Addendum A

Modifications to
Potomac Yard Urban Design Guidelines

Proposed Modifications Summary
Sections 2,3,4,5
May 28, 2010

Illustrative Townhouse Sections

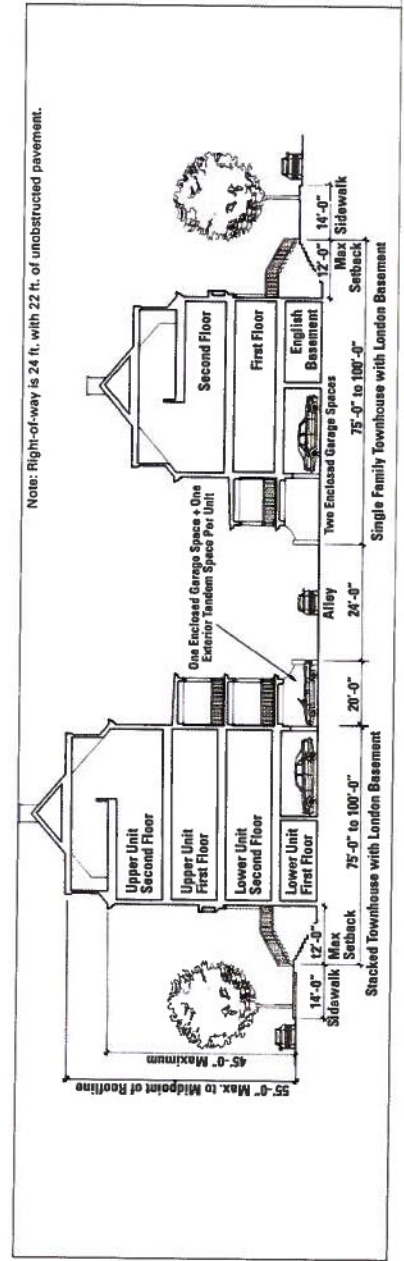
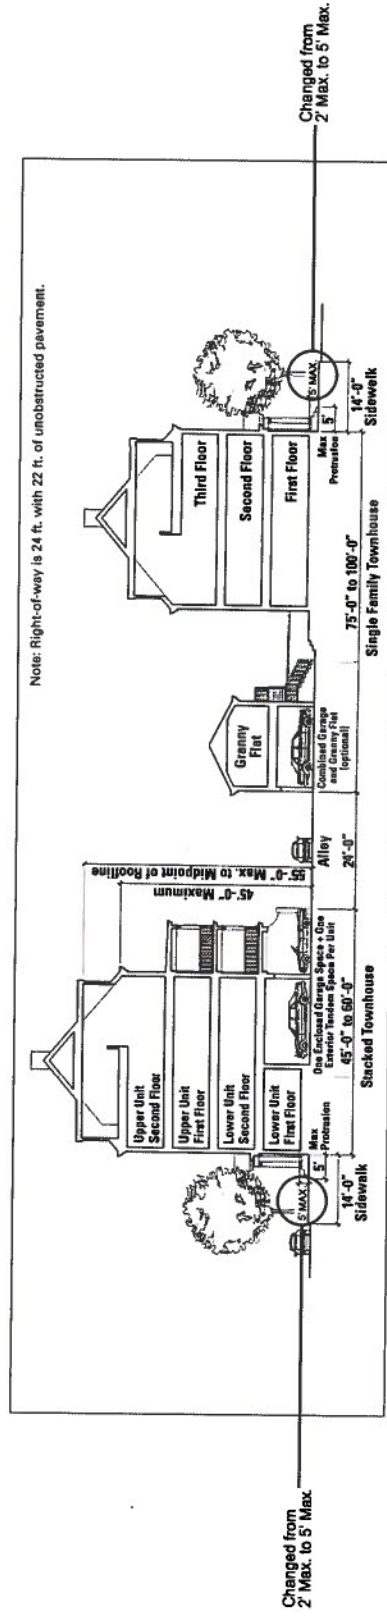
- PG.** February 6, 2007 Potomac Yard Urban Design Guidelines
PROPOSED TEXT and/or GRAPHIC REVISION
 May 28, 2010 Potomac Yard Urban Design Guidelines Addendum
- 58** No Change
Graphic revised to depict 5ft Max. between Finish Floor elevation and adjacent sidewalk.
- 58** Revised Illustrative Townhouse Section

February 6, 2007 Potomac Yard Urban Design Guidelines May 28, 2010 Potomac Yard Urban Design Guidelines Addendum
- 59** No Change
- 59** Revised Illustrative Townhouse Section

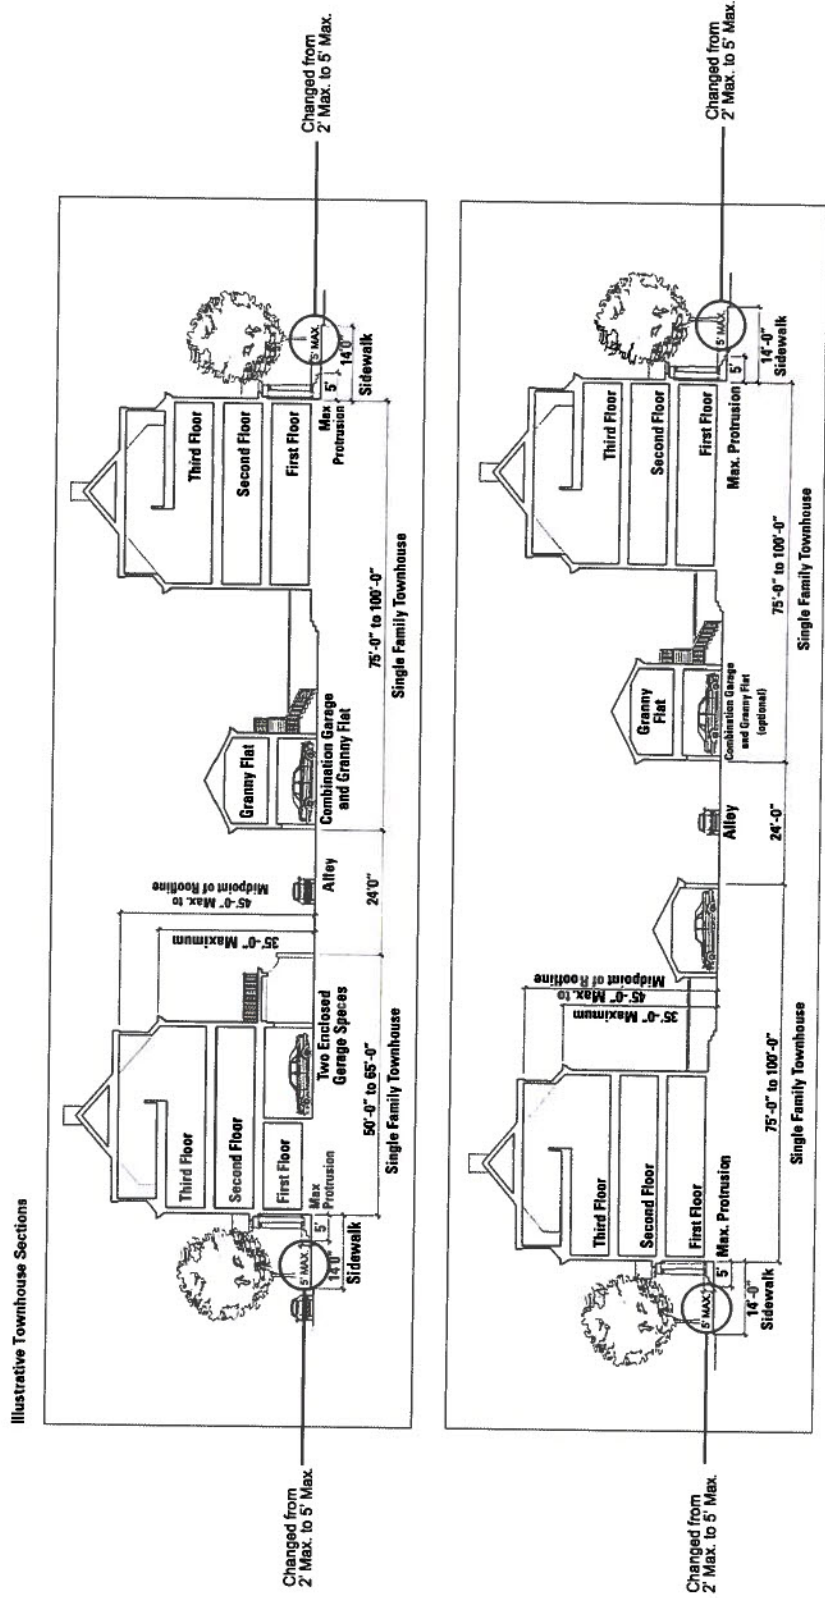
Graphic revised to depict 5ft Max. between Finish Floor elevation and adjacent sidewalk.
